Objection submission COM/2019/81 -

Dewatering not permitted (and additional Stormwater concerns)

Attachment A5 - Sediment build-up? Just beyond stormwater outlet in the Coomera River

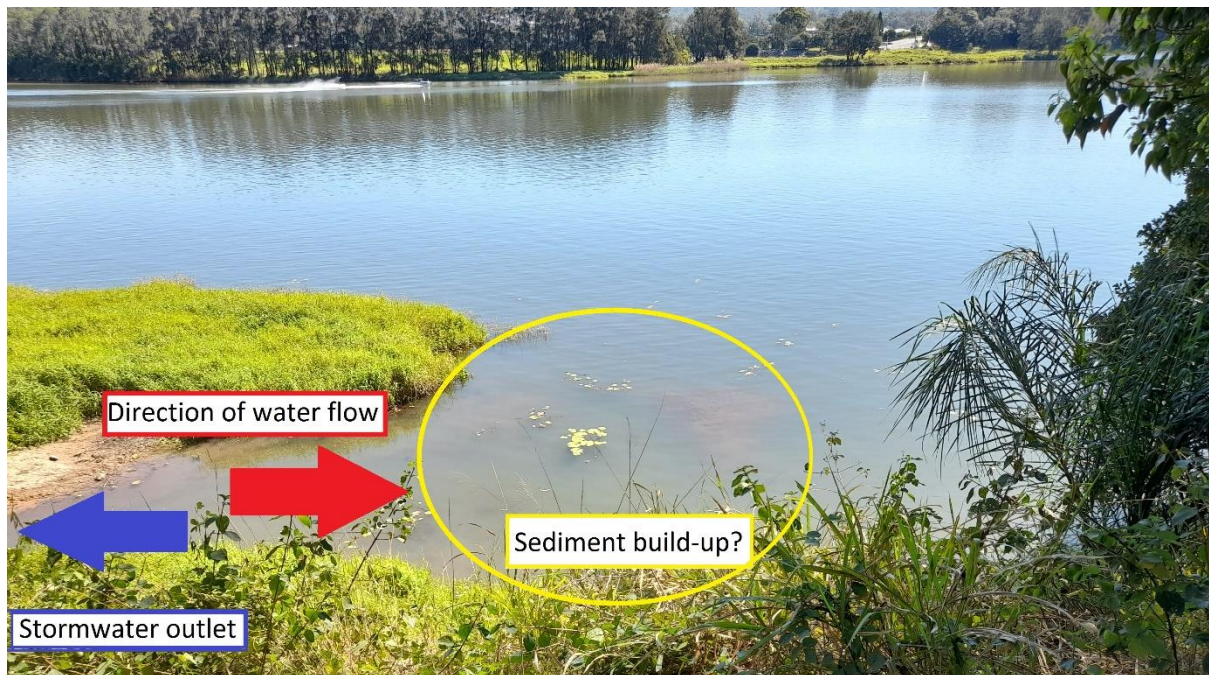
The sediment build-up in the Coomera River, that is I believe already happening, can be clearly seen just below the surface of the lake in Attachment A5. Which is just beyond the outlet of the stormwater drainage tunnel shown in attachment A1).

Attachment A7 - Dewatering pipe leading to the 'Overland Stormwater path'?

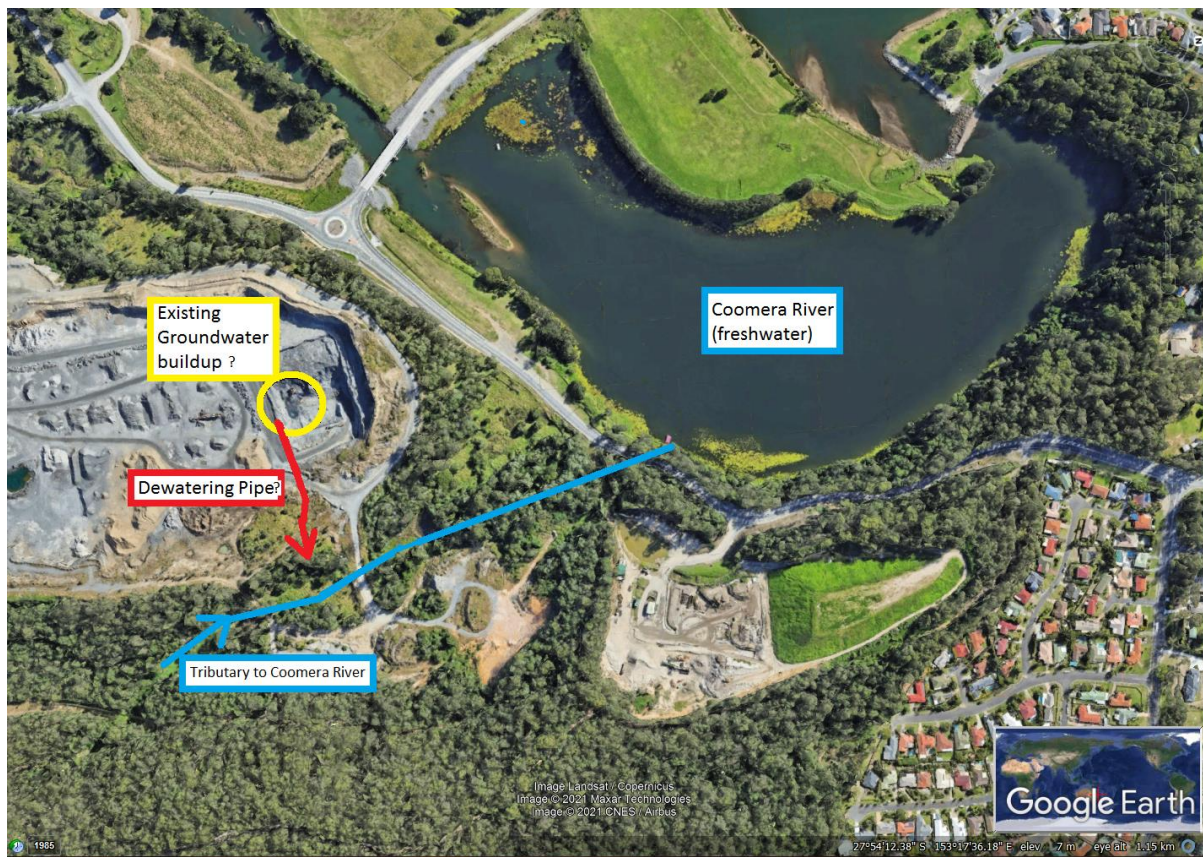
I believe the dewatering of this semi-subterranean area is via the pipe as shown in Attachment A7, A8 and A9). And, therefore, I can only assume this apparent link to the quarry is the root cause of the highly significant amount of the sediment build-up witnessed at the entrance to the stormwater drainage channel (attachment A1). I assume this is just a small percentage of the total outflow of sediment received by the *'Environmental significant - wetlands and waterways'* area of the freshwater section of the Coomera River (as can be seen by the sediment build up just beyond the exit of the stormwater drainage channel in attachment A5).

Attachment A10 - Subterranean mining area is 40 million cubic metres (approx)

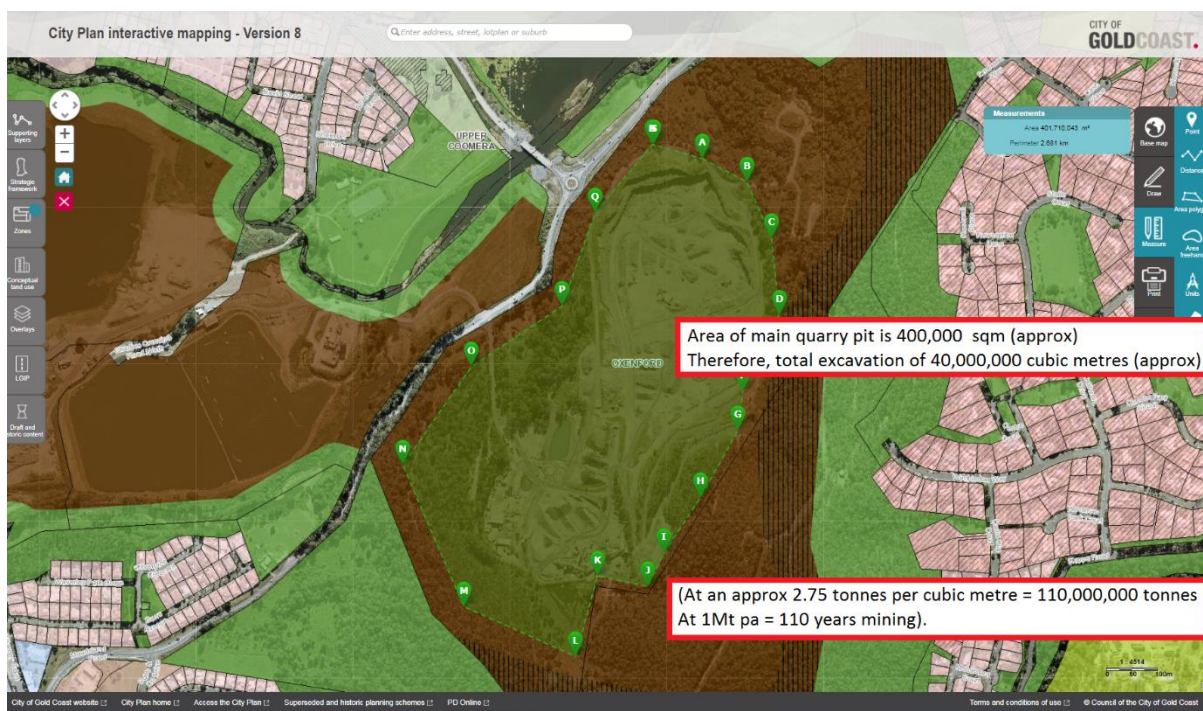
The total subterranean excavation proposed is, I believe, in the region of approximately forty million cubic metres (calculations shown in attachment A10).

Attachment C8 - Stage 6 - 'Sediment Basin C8', 'Polishing Dam C2', 'Dam C5' and 'Water Reuse Pond' engulfed in Extractive Footprint

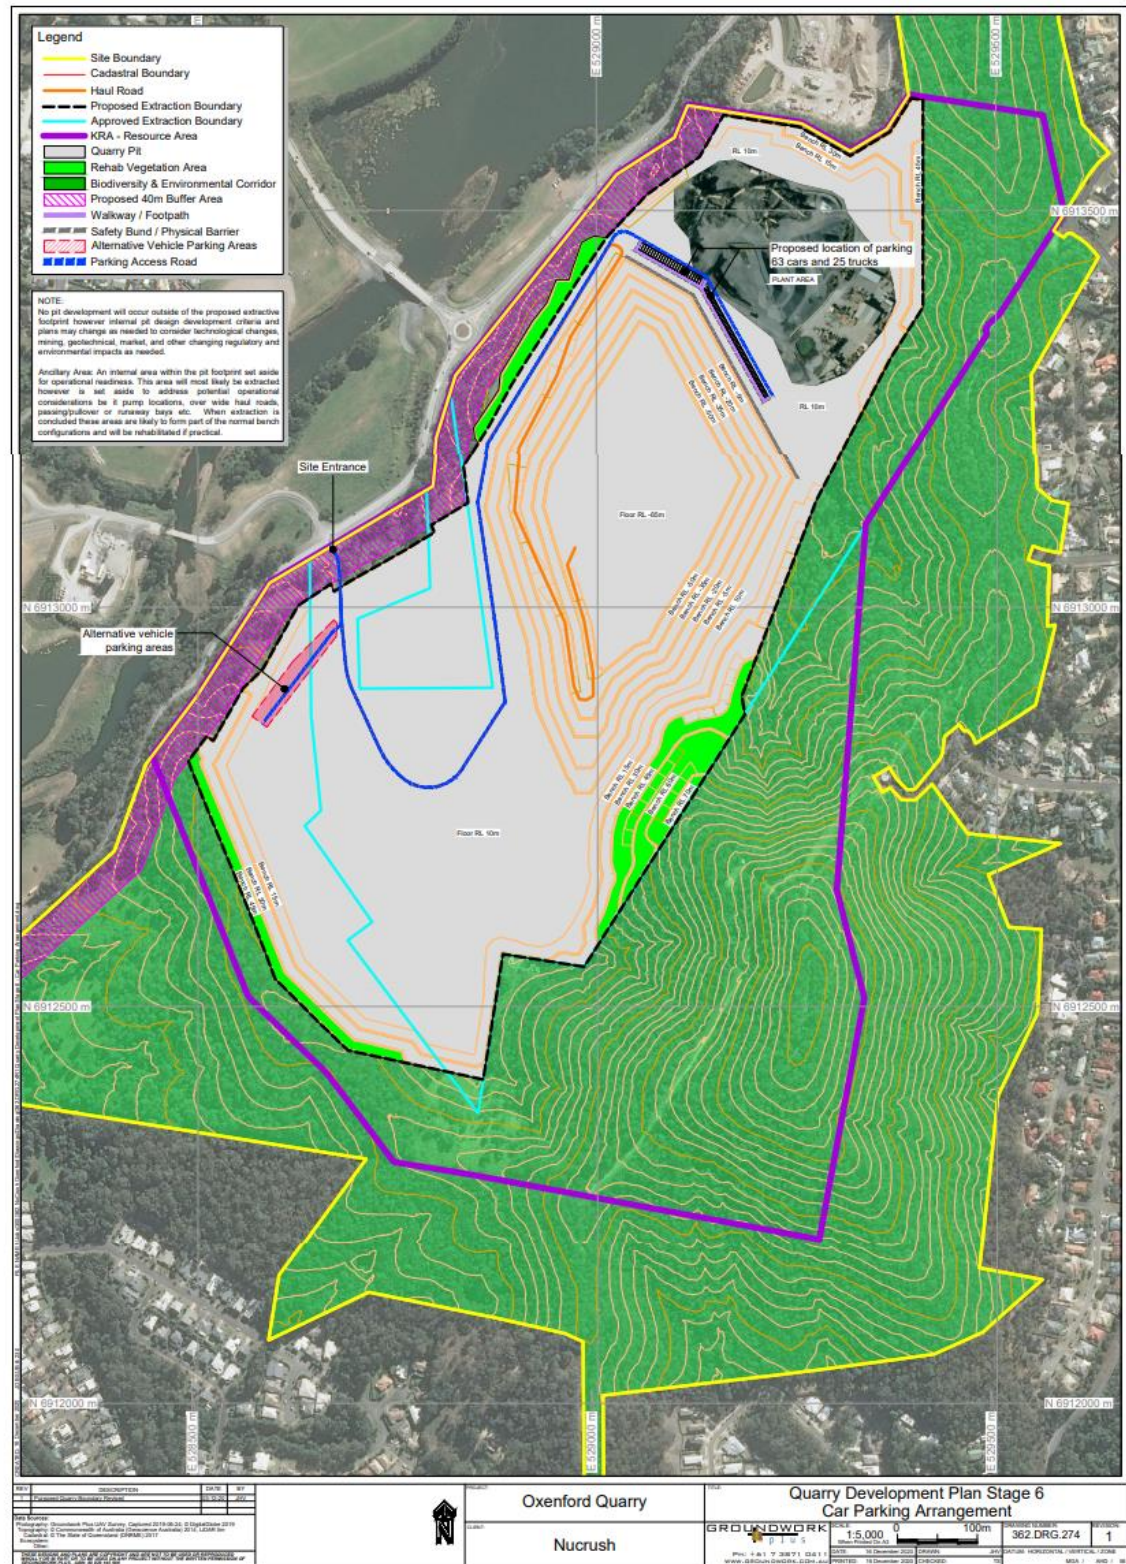
It should also be realised from early stages onwards the existing stormwater sedimentation basins and containment pits, dams etc. (as shown in Attachment C7) are engulfed into the extractive footprint and appear to have no replacements planned (as shown in attachment C8) over and above the main sump in the floor of the quarry (as shown in Attachment C9). Therefore, it would seem, there is absolutely nowhere to store the excess water to ensure it is at a compliant level of contaminants prior to being pumped into the *'Environmental significant - wetlands and waterways'* area of the Coomera River.

The proposed location of the car and truck parking and concrete production / batching facility and the main processing area (crushers, screeners, etc.) as shown in attachment C8, is I believe directly in the path of the 'Overland Stormwater Flow Paths', which is also an "Environmentally significant: Wetlands and Waterways" on the Gold Coast Council City Plan.

Attachment G4 - Bureau of Meteorology - Groundwater Dependent Ecosystems Atlas (Aquatic)

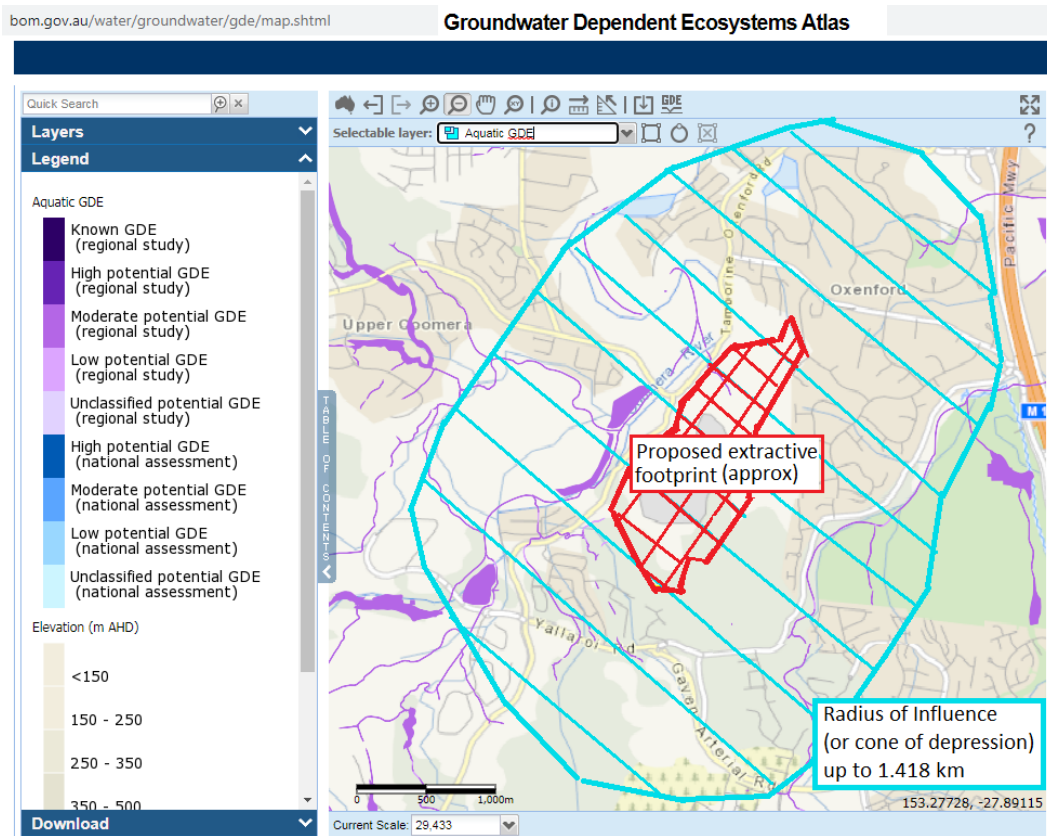
Unfortunately the *"The Bureau of Meteorology (BoM 2017) GDE Atlas"* maps referred to in the development application have not been submitted by the applicant. Therefore, in order to clarify the effects, I have added the proposed extractive footprint and the radius of influence onto these Bureau

Figure 7.3

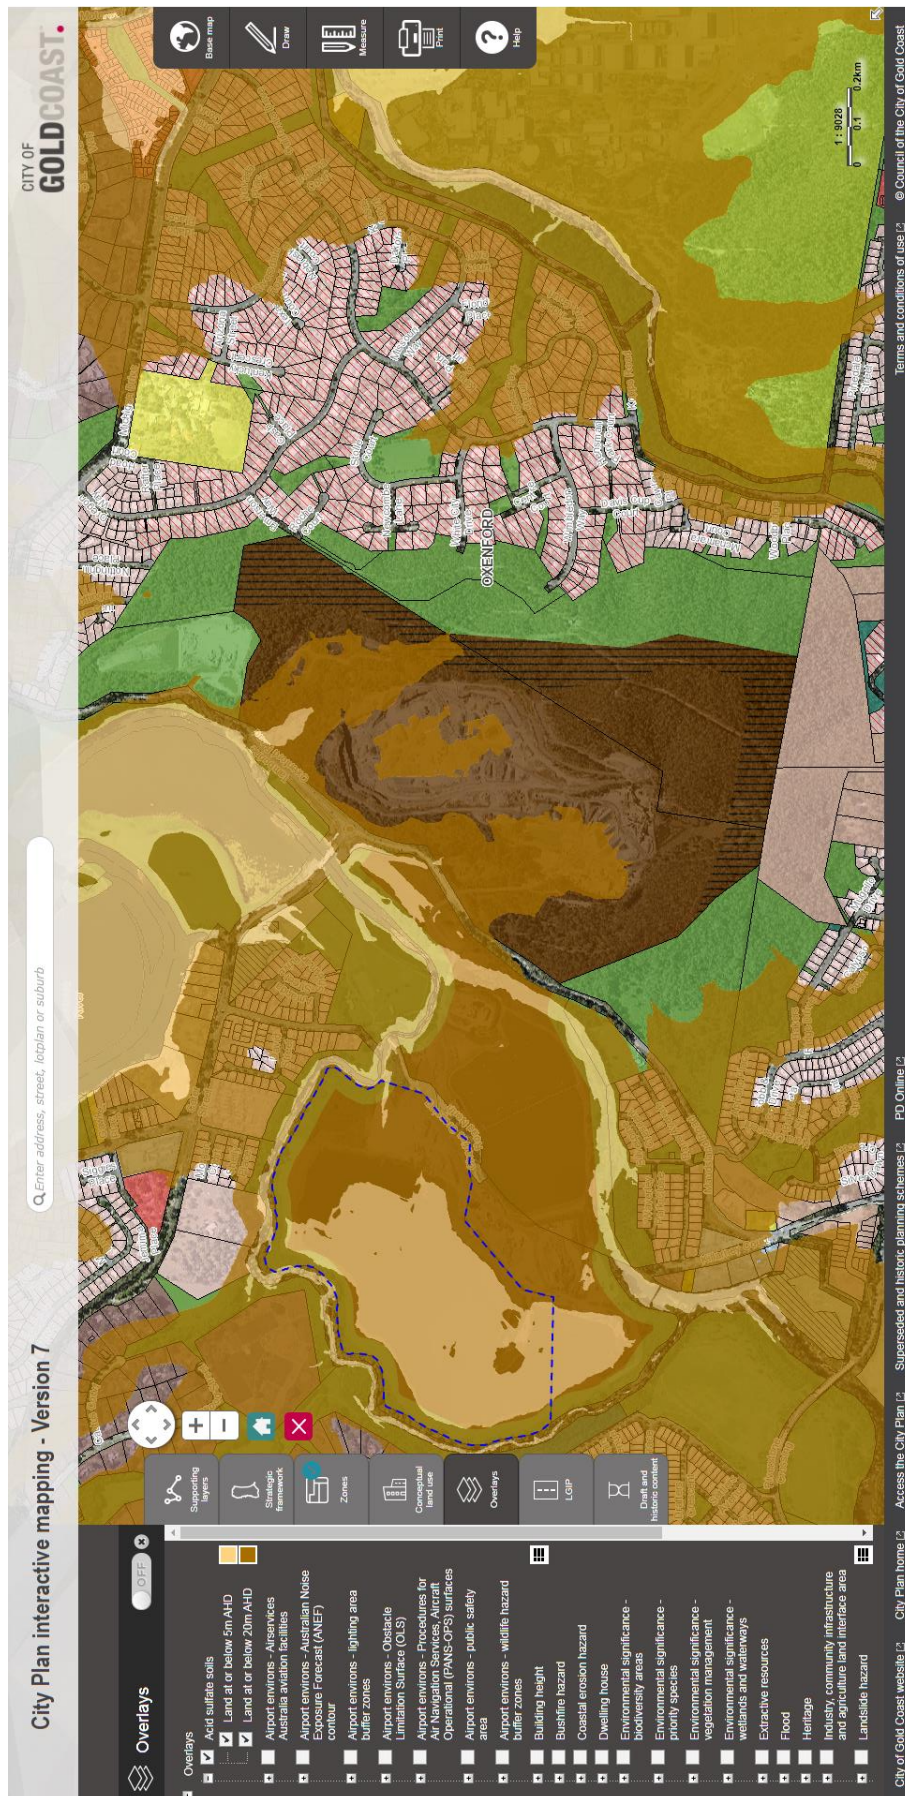
It is remarkable that the '*Groundwater Impact Assessment*', in a seeming desire to hide the proposed dewatering into the Coomera River that it's '*Conceptual Cross Section during operations*' (Figure 7.3) diagram appears to show the "*Existing groundwater flow in fresh bedrock*" as going upwards (Attachment J1).

Not only does this diagram, I believe, fail to show the extent of the quarry pit but it also fails to show how this leached ground water (from the mine walls and pit floor) will be dewatered from the quarry pit (other than appearing to show it as going upwards to the Coomera River!
